53 Fitzroy Park London

Supporting Documentation for
Planning Application

Structural Engineering Notes

Responses to Haycock Report, 18/07/11

job no: **209483**
drawing no: **SK-01**
revision: **P4**

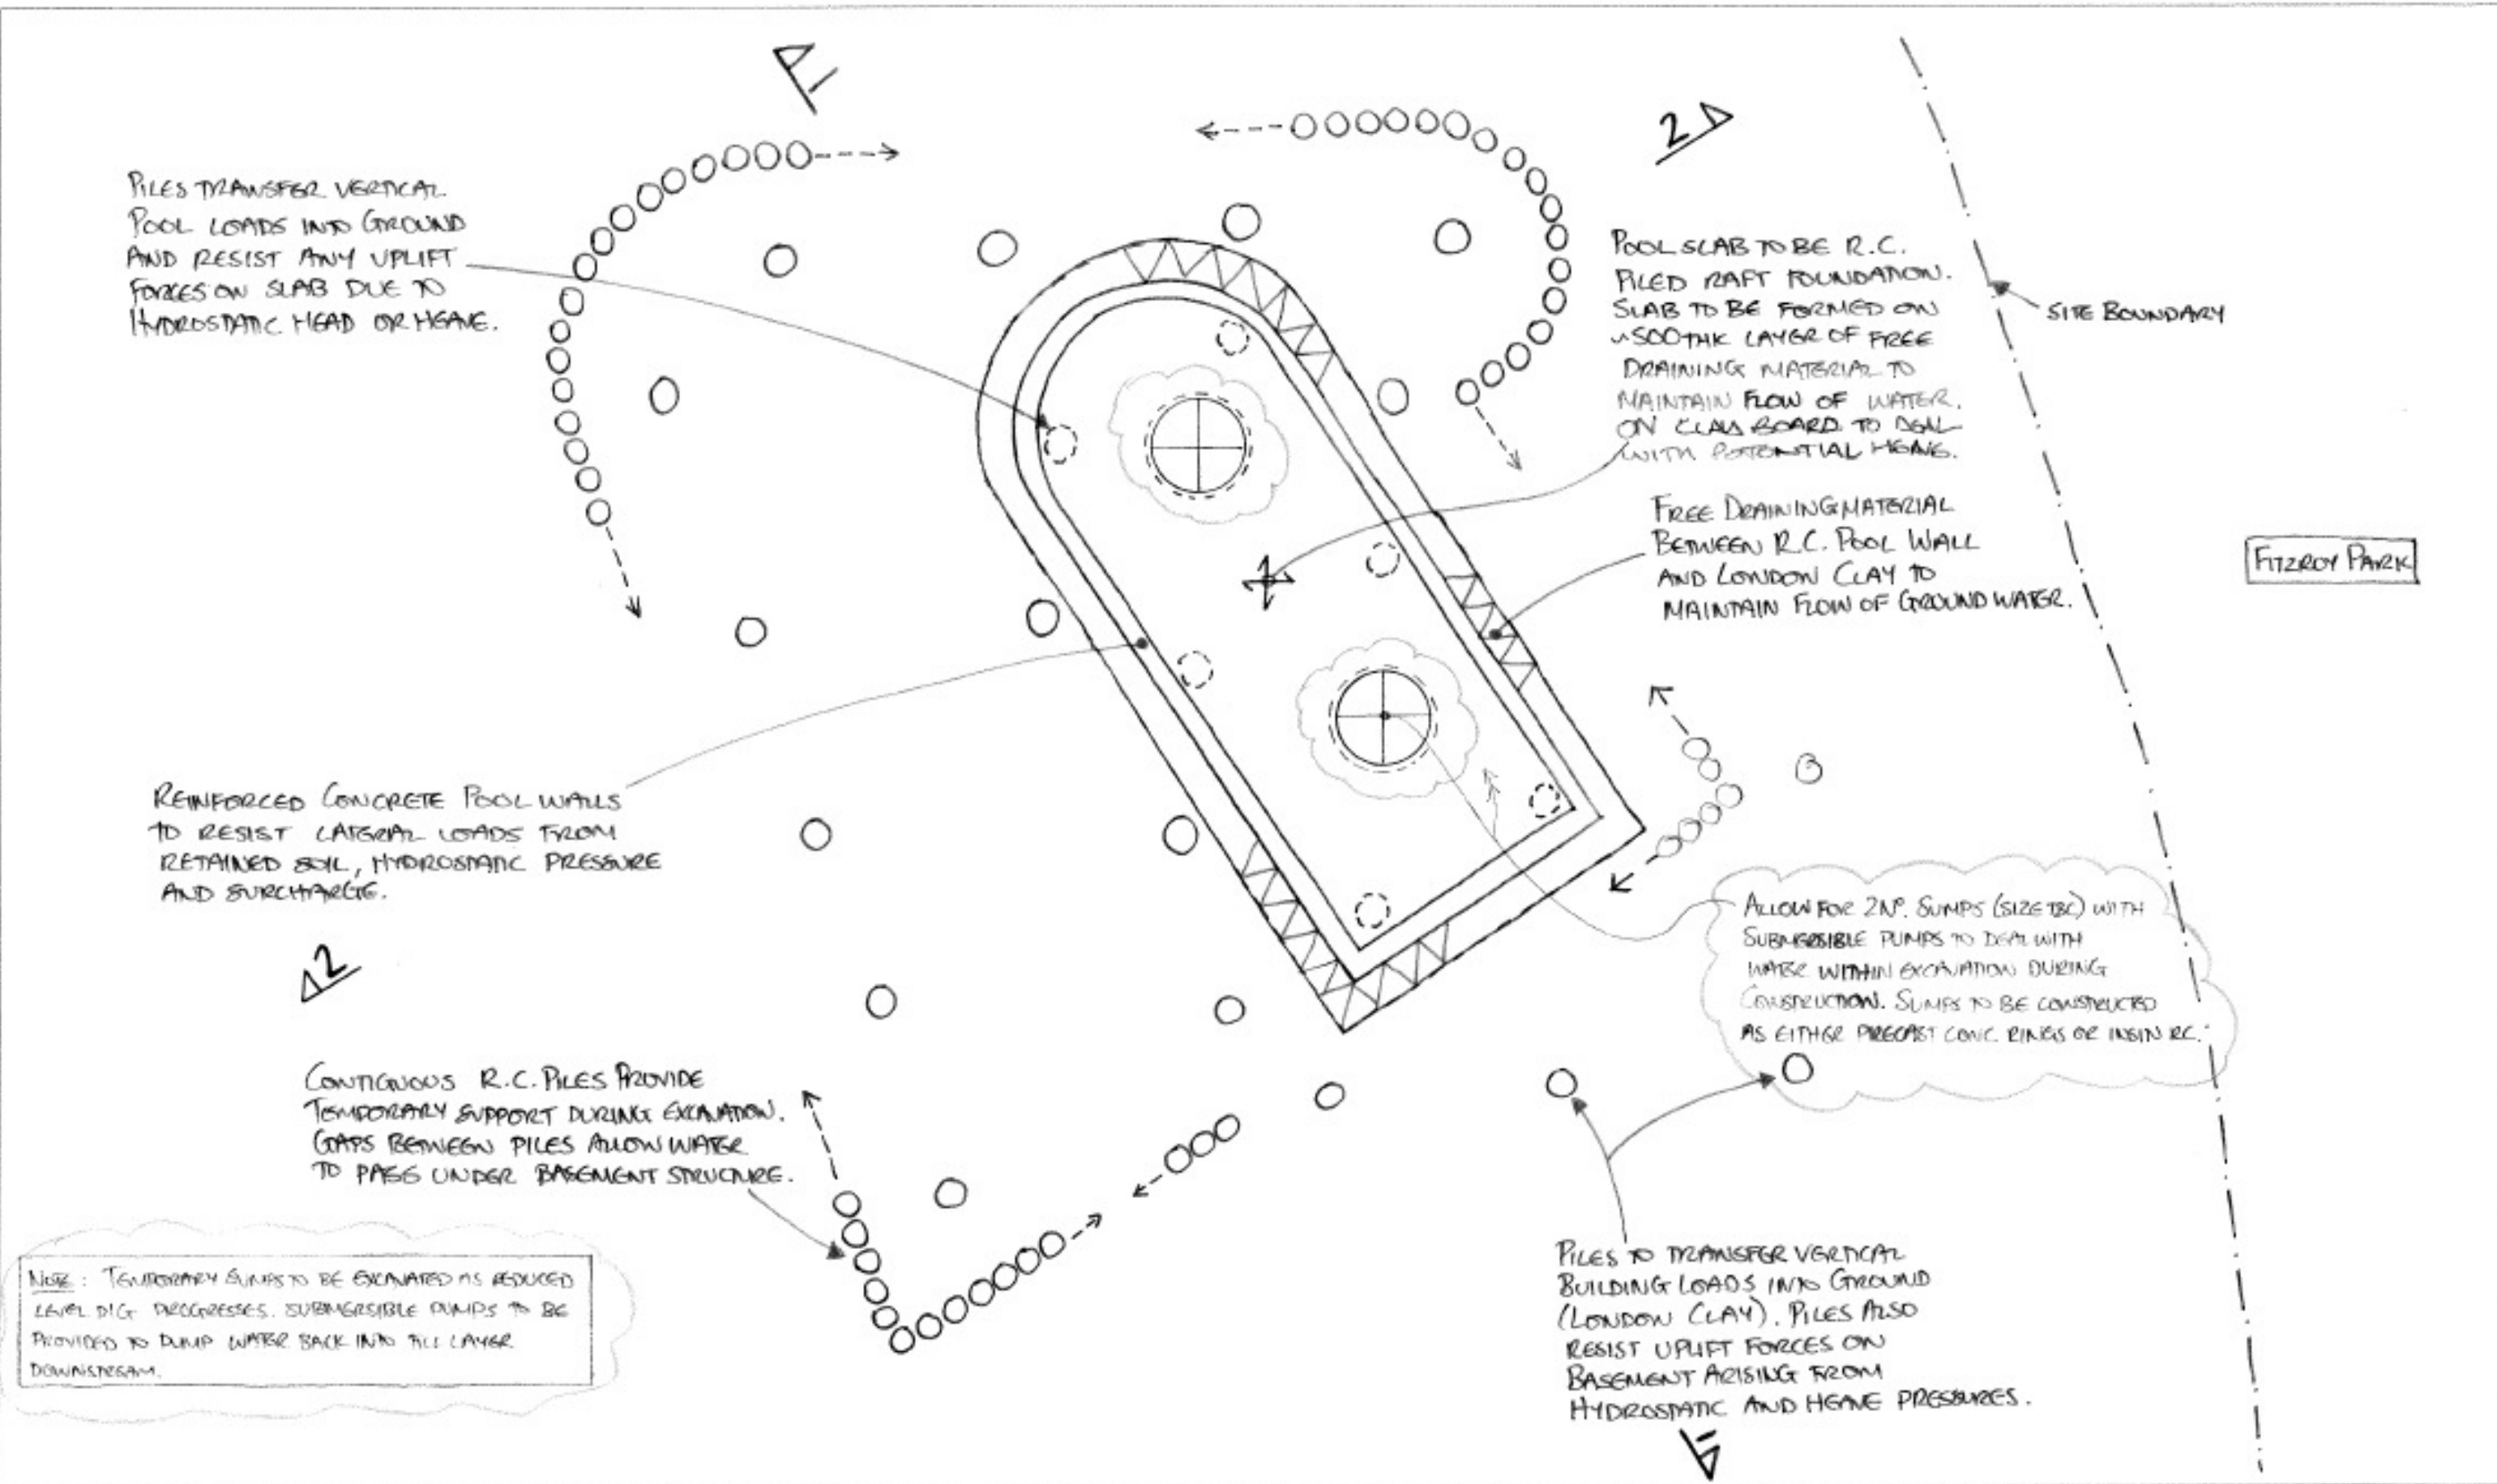
6.4 We believe the final methodology for sump/pumping of excavations would be provided by the contractor before commencement of the works. However, we have indicated a suggested methodology in our assumed sequence of works in section 6.0 of this report, and also indicated possible sump locations on drawings SK-01, SK-10 and SK-11.
